Submissions Report

Pymont Over Station Development

October 2024

Figure 5-1 Elizabeth Healey Reserve sun access plane and proposed building envelope in blue

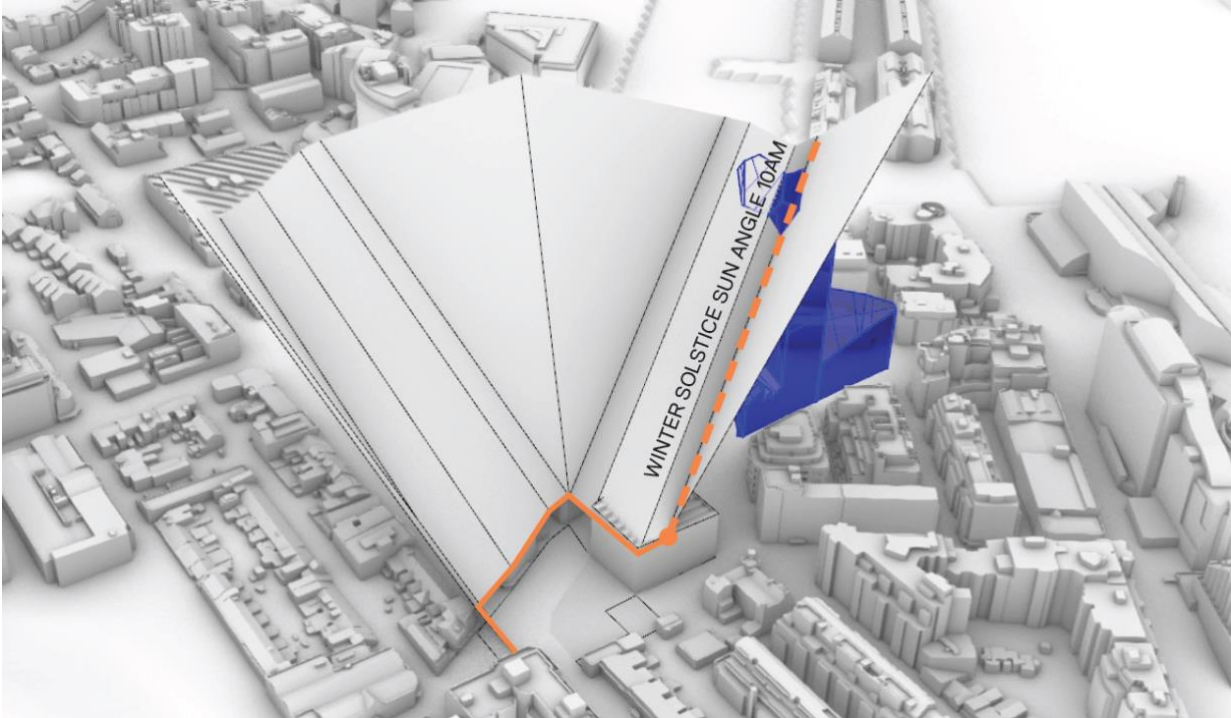
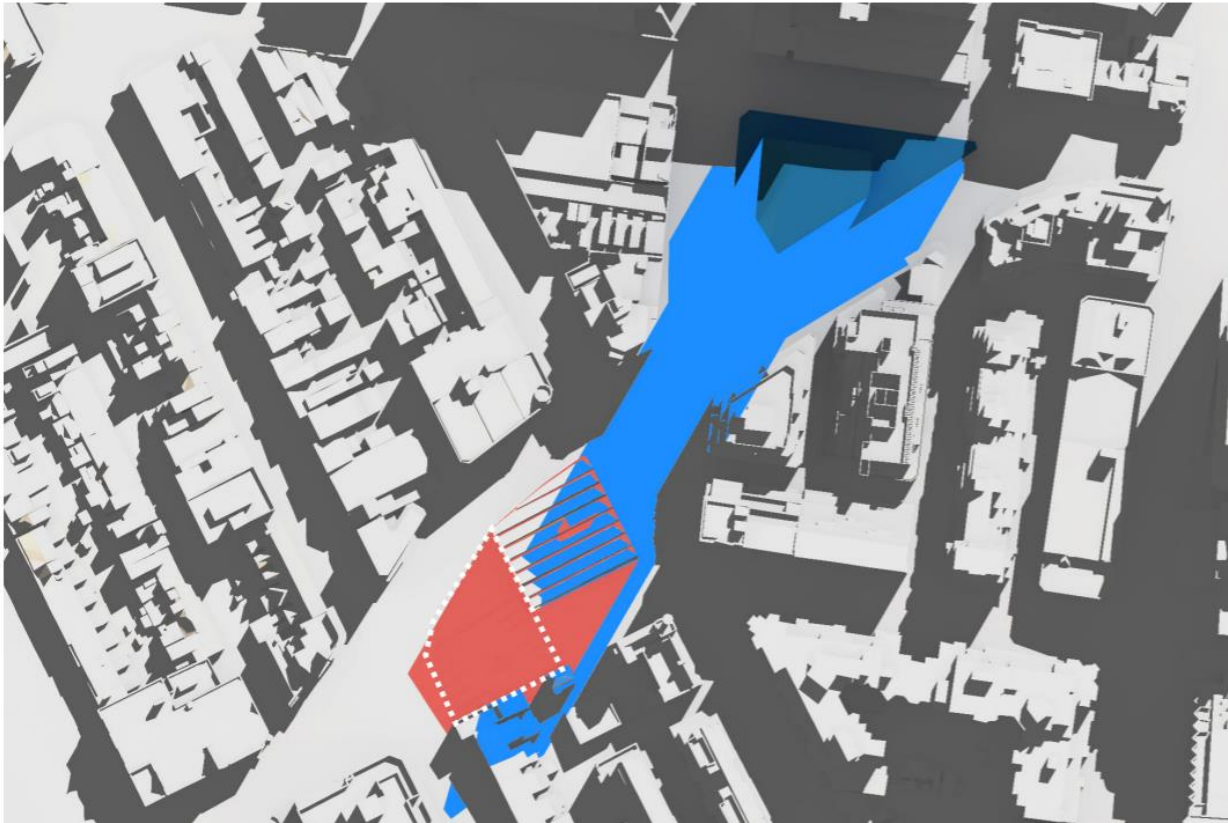
Issued raised	Sydney Metro response
<p>The Solar Access Report (Appendix M) does not identify or test the Solar Access Plane (SAP) to Elizabeth Healey Reserve to the south-west of the site. The Pymont Peninsula Place Strategy – Urban Design Report identifies the SAP requiring developments to ensure that there would be no additional overshadowing between 10am and 2pm in mid-winter.</p> <p>This is given weight under this application as Section 4.2.2.2.c of the Pymont Peninsula Design Guidelines requires:</p> <p><i>“Maximum street wall and buildings heights are to respond to adjacent and surrounding development, and:</i></p> <p>...</p> <p><i>c. ensure no additional overshadowing to Elizabeth Healy Reserve”</i></p> <p>A 3D electronic model has been requested to enable testing to be undertaken to confirm the SAP is not broken by the proposed building envelope. A section provided through the building appears to exceed the SAP as shown in figure 1 below.</p>	<p>The project architect has prepared a 3D CAD model to demonstrate the extent of overshadowing to Elizabeth Healey Reserve (RTS Appendix C). The 3D model confirms that the proposed development does not result in any additional overshadowing to Elizabeth Healey Reserve at the relevant times. Whilst there is an exceedance of the sun access plane, this does not result in any additional overshadowing to the Reserve due to that part of the Reserve already being overshadowed at that time by the existing Woolshed Building (137 Pymont Street).</p> <p>The additional shadow diagrams provided in Appendix C identify overshadowing impacts to the Elizabeth Healey Reserve including a portion of the adjoining road reserve (Gipps Street) which may be used for future expansion of the Reserve.</p> <p>Specifically, the additional shadow diagrams identify:</p> <ul style="list-style-type: none"> • the proposal’s overshadowing at 5-minute intervals at mid-winter between 10am and 10:20am • the boundaries of the Elizabeth Healey Reserve (including the portion of the adjoining road reserve (Gipps Street) which may be used for future expansion of the Reserve) • sun’s eye views with the boundaries of the Reserve. <p>The additional shadow diagrams confirm that the proposed development does not result in any additional overshadowing to the Elizabeth Healey Reserve within the prescribed periods, including to the portion of the adjoining road reserve (Gipps Street).</p>

The project architect has prepared additional diagrams to illustrate the sun access plane to Elizabeth Healey Reserve and its interaction with the proposed development (RTS Appendix C). The diagrams, prepared at 5-minute intervals during the winter solstice between 10am and 10.20am, demonstrate the impact of the building envelope on the solar access to the Reserve, having regard to existing intermediary buildings including 137 Pyrmont Street.

The diagrams demonstrate that the proposed development does not create any additional overshadowing to the Reserve at the relevant times, as shown in Figure 5-1 and Figure 5-2. Whilst there is an exceedance of the sun access plane, this does not result in any additional overshadowing to the Reserve, as the resultant shadow falls within an existing shadow to the Reserve at that time, cast by the existing Woolshed Building (137 Pymont Street). The overshadowing diagrams (RTS Appendix C [pgs. 6 – 10]) illustrate that the building envelope does not cast any additional shadows onto the Elizabeth Healey Reserve in accordance with Section 4.2.2.2.c of the Pymont Peninsula Design Guidelines.

Figure 5-3 Elizabeth Healey Reserve Extent

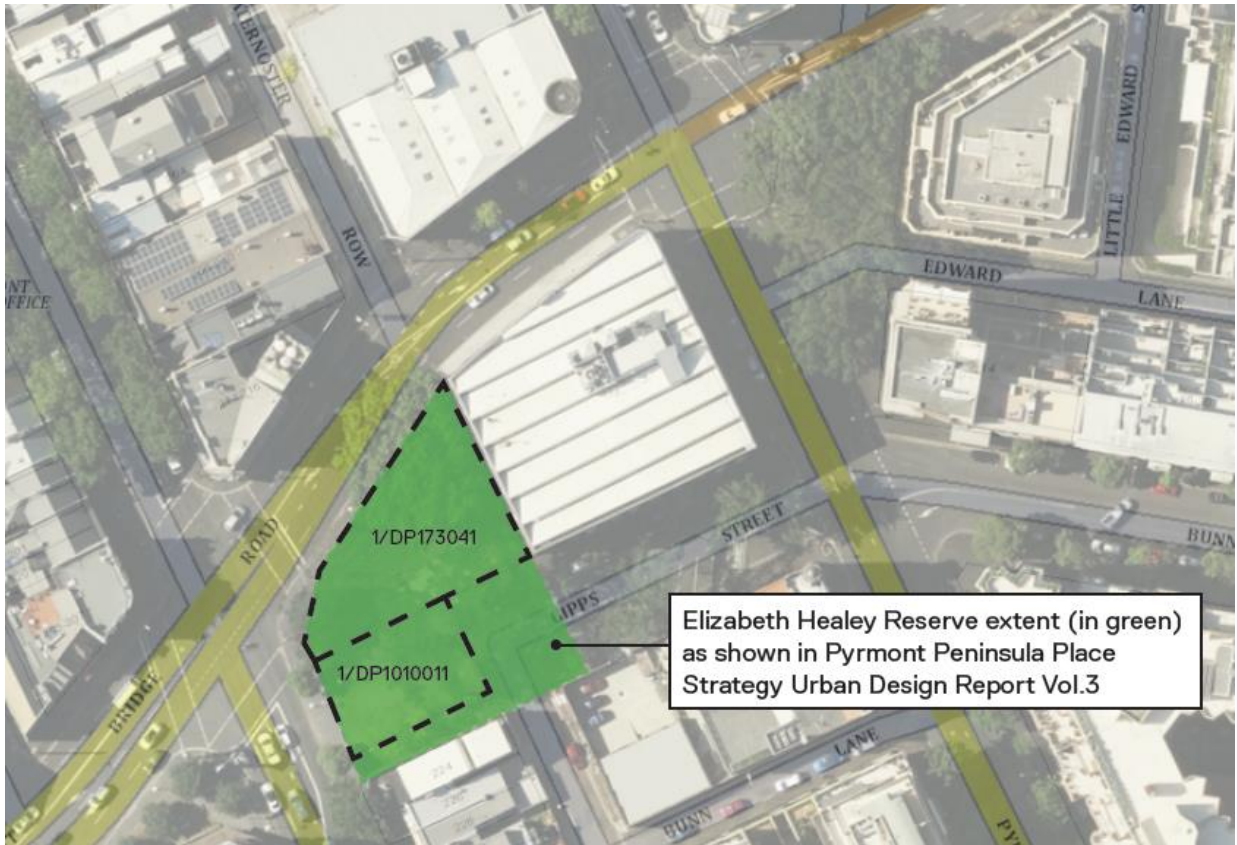
- the proposal’s overshadowing at 5-minute intervals at mid-winter between 10am and 10:20am
- the boundaries of the Reserve
- sun’s eye views with the boundaries of the Reserve.

The boundaries of the Elizabeth Healey Reserve are provided in Figure 5-3 and comprise Lot 1 in DP 173041 and Lot 1 in DP 1010011 and a portion of the adjoining road reserve (Gipps Street). This consolidated parcel of land is consistent with the Proposed Sun Access Plane diagram in the Pyrmont Peninsula Place Strategy Urban Design Report Volume 3 (sub-precinct master planning). The inclusion of a portion of the adjoining road reserve (Gipps Street) in the sun access plane modelling is to ensure adequate solar access can be achieved for a possible future expansion of the Reserve.

Detailed shadow diagrams of the proposed development at 5-minute intervals during the winter solstice between 10am and 10:20am are provided in RTS Appendix C [pgs. 6 – 10]. The additional shadow diagrams confirm that the proposed development does not result in any additional overshadowing to the Reserve (including to the portion of the adjoining road reserve (Gipps Street) identified for a potential future expansion of the Reserve).
